1984 - 1987 Corvette: Service Bulletin: Rattle From Turn Signal Lever

Subject: Rattle From Turn Signal Lever

Bulletin Number: 87-224, Section 10

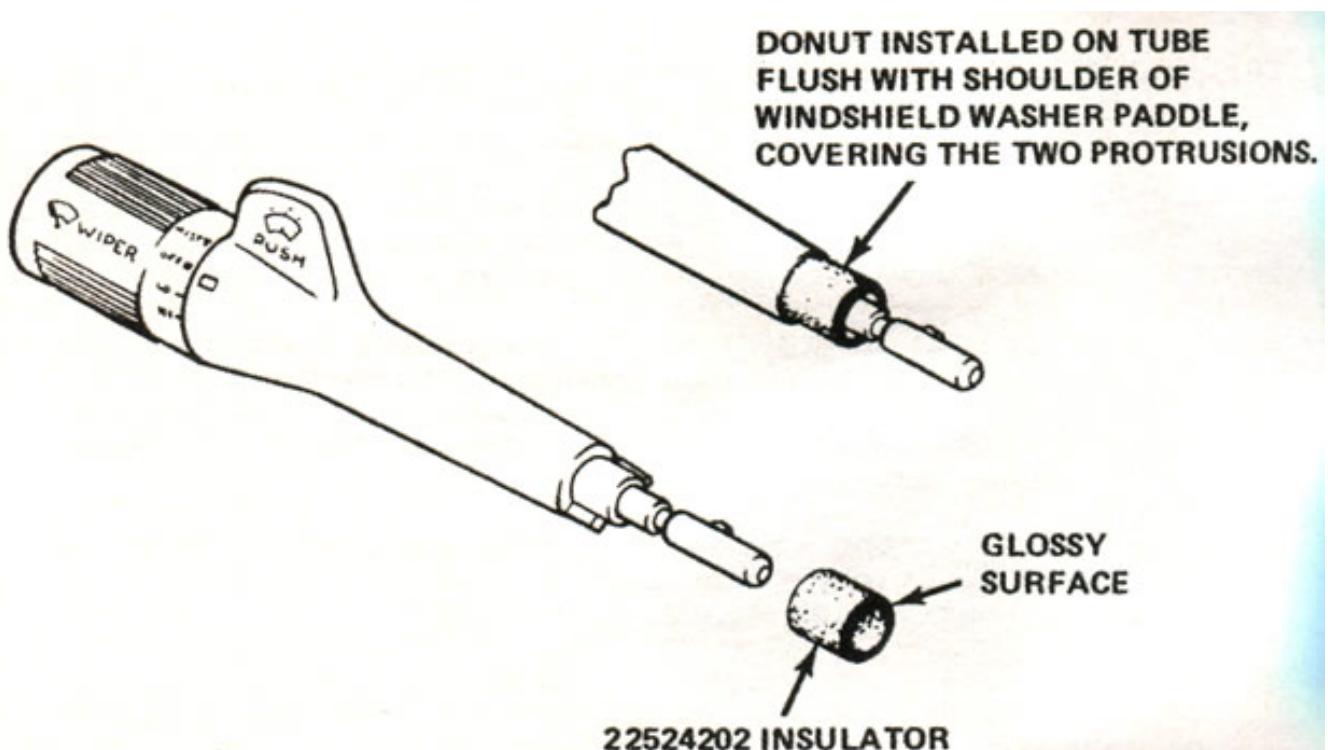
A rattle-type noise originating from the multi-function turn signal lever may be caused by excess looseness or play in the windshield washer actuator paddle.

This condition can be repaired by installing a foam rubber "donut" on the lever using the following procedure:

6. Install the foam "donut" to the turn signal lever as shown on the illustration, making sure that the "donut" is positioned over the two (2) protrusions at the end of the windshield washer paddle and flush against the shoulder of the paddle. NOTICE: The "donut" has a glossy appearance at one end. It may be easier to install the "donut" with the glossy end AWAY from the shoulder of the paddle.
7. Re-assemble the turn signal lever assembly to the steering column by pushing it back into the turn signal switch. Check the lever for proper function of all switches.
